# UNITED STATES PATENT AND TRADEMARK OFFICE

<b>Office Action Summary</b>	<b>Application No.</b> 10/801,265	<b>Applicant(s)</b> BONNET ET AL.	
	<b>Examiner</b> William H. Rodriguez	<b>Art Unit</b> 3746

### FINAL REJECTION

FIG. 1  
PRIOR ART

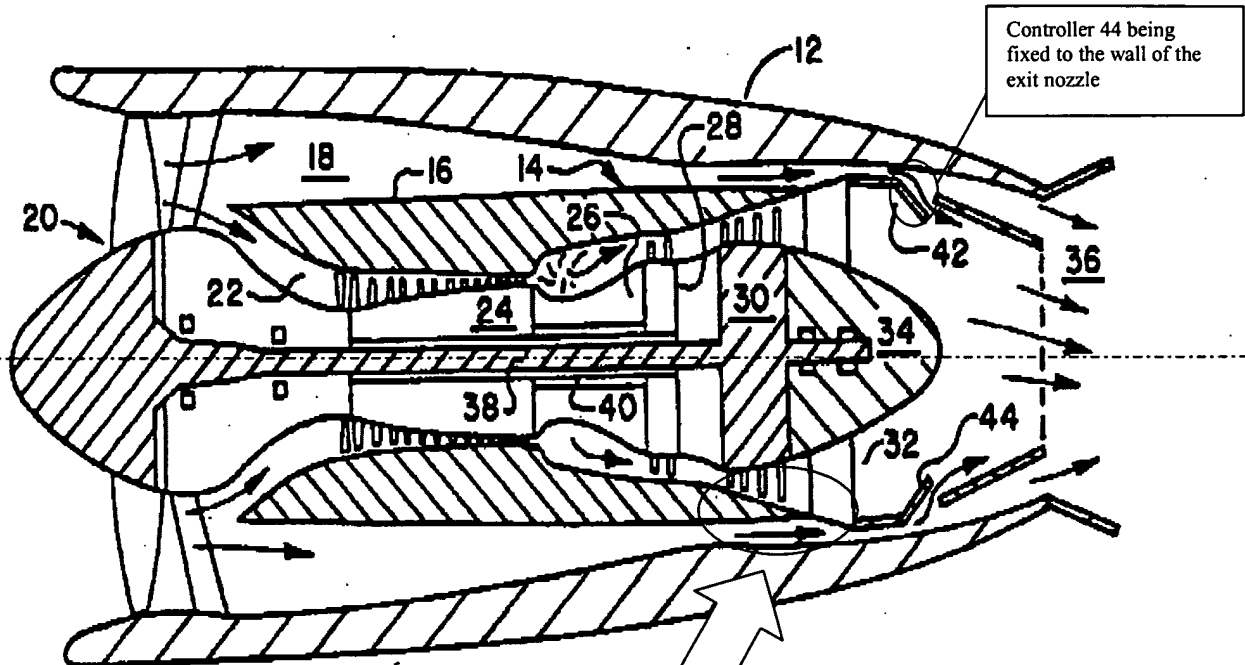
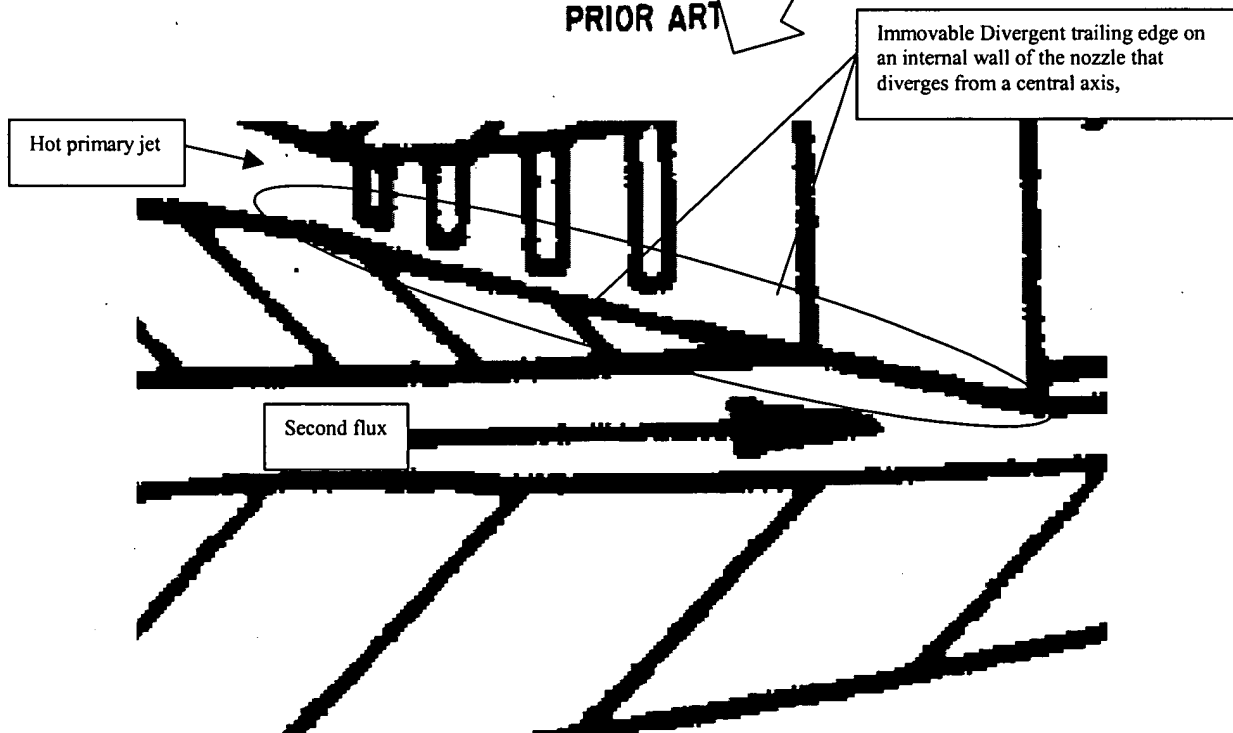
**McAndrews** teaches that the primary jet is separated from a wall (separated state) when the controller is activated (as shown in Figure 1) and the primary jet is reattached to the wall (reattached state) when the controller is deactivated. Therefore, the primary jet controller 44 of **McAndrews** performs the desired expected results as expected by the controller of the invention, that is, it (44) enables control of passage of the primary jet from a separated state to a reattached state and vice versa.

With respect to claims 15 and 29, **McAndrews** teaches an engine having a device for controlling propulsive gas mixing at an outlet of said engine, wherein propulsive jets are composed of a hot primary jet exiting from a nozzle of the engine and a secondary flux flowing between an external wall of the nozzle and an internal wall of the engine, the device comprising: a divergent trailing edge/immovable trailing edge on an internal wall of the nozzle that diverges from a central axis extending along the jet engine and generates conditions of a minimal separation of the primary jet from the internal wall; and a primary jet controller that enables control of passage of the primary jet from a separated state to a reattached state, and vice versa; the controller being fixed to the wall of the exit nozzle relative to the primary jet; and the divergent trailing edge being in a fixed position with respect to the wall of the nozzle. See particularly **Figure 1** of **McAndrews** above.

With respect to claim 16, **McAndrews** teaches that controlling the separation of the primary jet is periodic (elements 42, 44 open and close periodically depending on the mode of operation). See particularly **Figure 1** of McAndrews above.

With respect to claims 23 and 24, **McAndrews** teaches that the controller is arranged on a part of the circumference of the internal wall of the nozzle and on a part of the external wall of the nozzle. See particularly **Figure 1** of McAndrews above.

With respect to claim 25, **McAndrews** teaches that control of the separation of the primary jet is implemented at the trailing edge. See particularly **Figure 1** of McAndrews above.

With respect to claim 26, **McAndrews** teaches that control of the separation of the primary jet is implemented to generate either a symmetrical flow or an antisymmetrical flow at the outlet of the engine. See particularly **Figure 1** of McAndrews above.

With respect to claim 27, **McAndrews** teaches that the trailing edge has an angle with the wall of the nozzle between about 10 and about 30 degree as shown in **Figure 1** of McAndrews above.

With respect to claim 28, **McAndrews** teaches that the wall of the nozzle is convergent upstream of the trailing edge. See particularly **Figure 1** of McAndrews above.

On page 7 of the response, applicant argues that McAndrews divergent trailing edge is not stationary but movable. Examiner respectfully disagrees because as clearly shown in Figure 1 above, McAndrews divergent trailing edge is stationary, the controller 44 is the one that moves from an activated position to a de-activated position. See particularly **Figure 1** of McAndrews above.
